Item 3.**Development Application: 1-3 Goddard Street, Erskineville - D/2019/880**

File No.: D/2019/880

Figure 15: the setback at the western boundary has been increased from 6m to 9m at the south-western corner of the site, to minimise the extent of tree pruning required for a tree located within 5 Goddard Street.

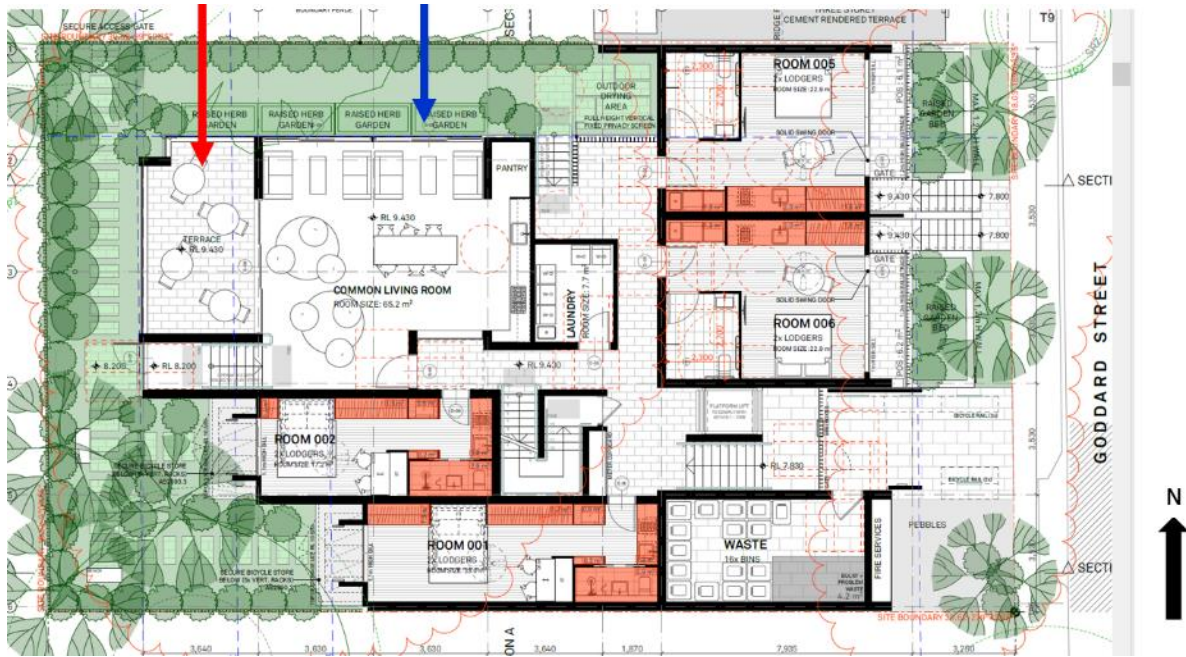
- (b) External balconies facing Goddard Street have been reduced in depth, to ensure canopy trees can reach maturity within the street setback;
 - (c) Internal and external communal areas have been reconfigured to increase their amenity and reduce visual privacy impacts for neighbouring dwellings to the north. An outdoor terrace area has been relocated from the northern edge of the communal living room to the western edge (Figure 16);

Figure 24: shadow diagrams for 2.00pm and 3.00pm on 21 June, showing that additional shadows will fall on to the roof of the existing dwelling at 5 Goddard Street. Black arrows indicate the roof of the dwelling and solar access retained from 2.00pm.

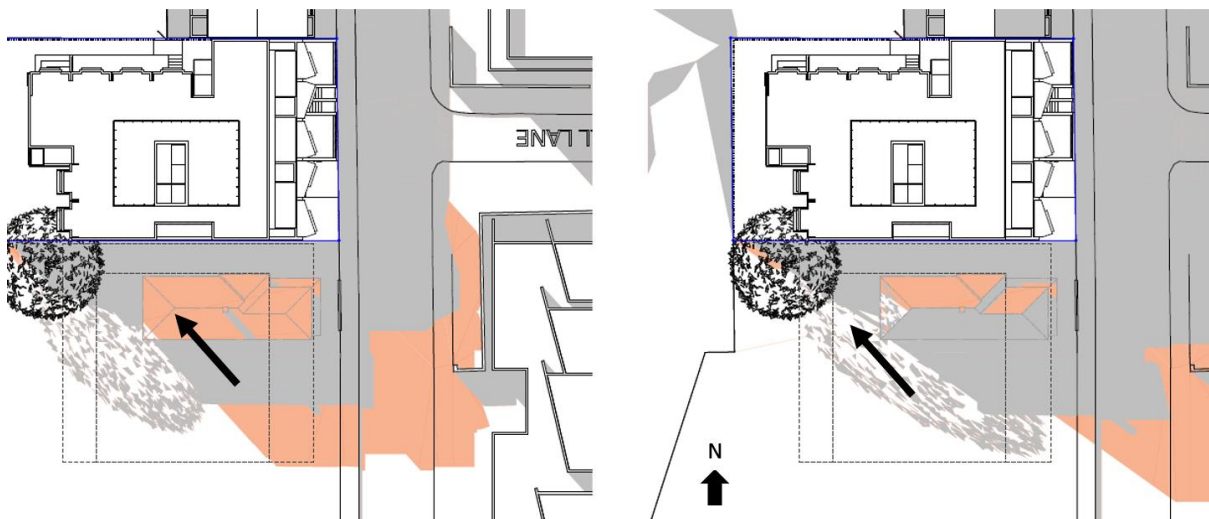
44. Located within 5 Goddard Street to the south is a single storey detached dwelling (Figure 8 above):
- (a) the provisions of part 4.1.3.1 of SDCP2012 specify that neighbouring dwellings are to achieve a minimum of 2 hours direct sunlight between 9.00am and 3.00pm on 21 June onto at least 1sqm of living room windows and at least 50% of the minimum amount of private open space; and that new development must not create any additional overshadowing where solar access is less than two hours between 9.00am and 3.00pm on 21 June.

- (iii) additional overshadowing caused by the proposed boarding house will fall onto the roof of the dwelling from 2.00pm onwards (Figure 24 below). The rear private open space retains existing solar access in the afternoons from 2.00pm onwards on 21 June.

Figure 28: Section plan, showing the proposed building height exceeding the 12m SLEP2012 control (dashed red line added for emphasis). The proposed maximum building height is 12m above the required floor levels as per flood engineer's advice.

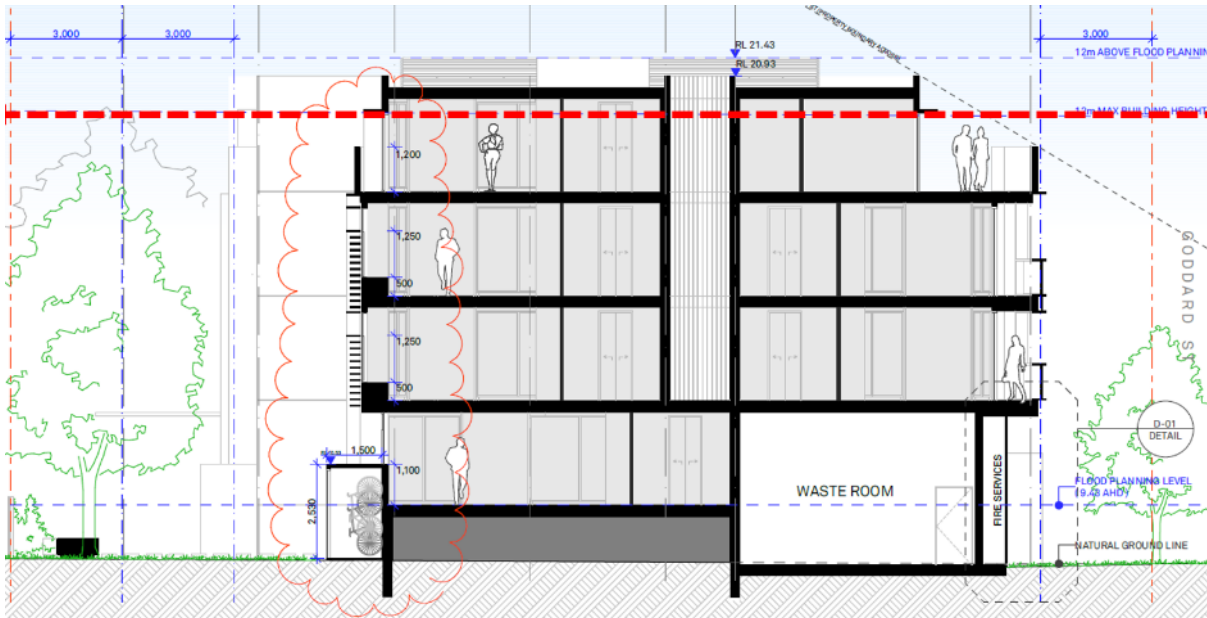
47. The site is subject to a maximum building height control of 12m. The proposed development has a maximum height of 13.56m and exceeds the control by 1.56m (13%) - see Figure 28 below. The proposed development has a height of 4 storeys and exceeds the maximum 3 storey height control as shown in the relevant SDCP2012 Ashmore Height in Storeys map.

Figure 29: A condition is recommended that rooms 001 and 002 be consolidated to create an additional adaptable boarding room (shaded blue for emphasis) and additional bike parking spaces (shaded yellow for emphasis).

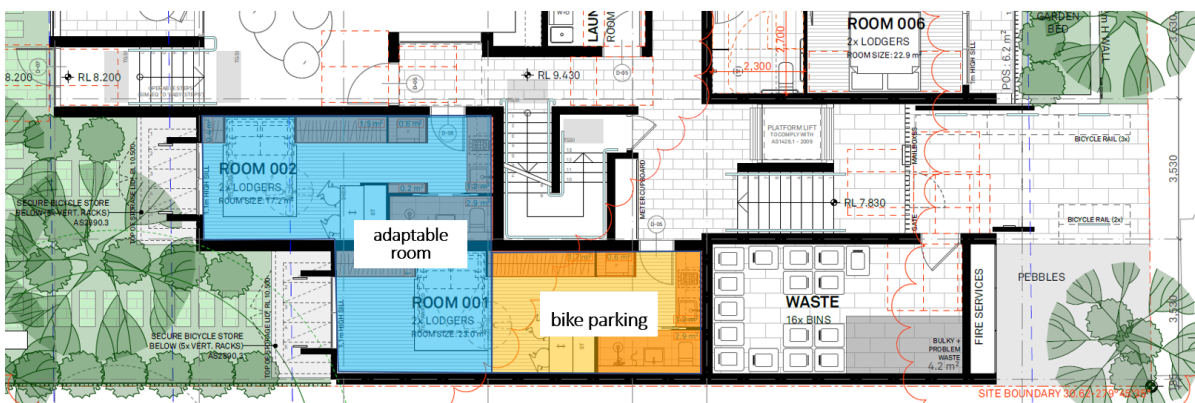
75. A deferred commencement approval is recommended to address the shortfall in the provision of adaptable dwellings, by way of consolidating boarding rooms 001 and 002 at ground level.

76. This condition will ensure that all ground level rooms are capable of being adaptable and will increase the quantum of adaptable rooms from 6% to 9%. This design refinement will also provide scope for additional bicycle parking spaces. See discussion below and Figure 29.

80. The remnant portion of room 001 at the ground level of the building (where it has been consolidated with room 002 to provide an additional adaptable room) must be used to provide additional bike parking spaces and to maximise the provision of adaptable rooms as set out above.
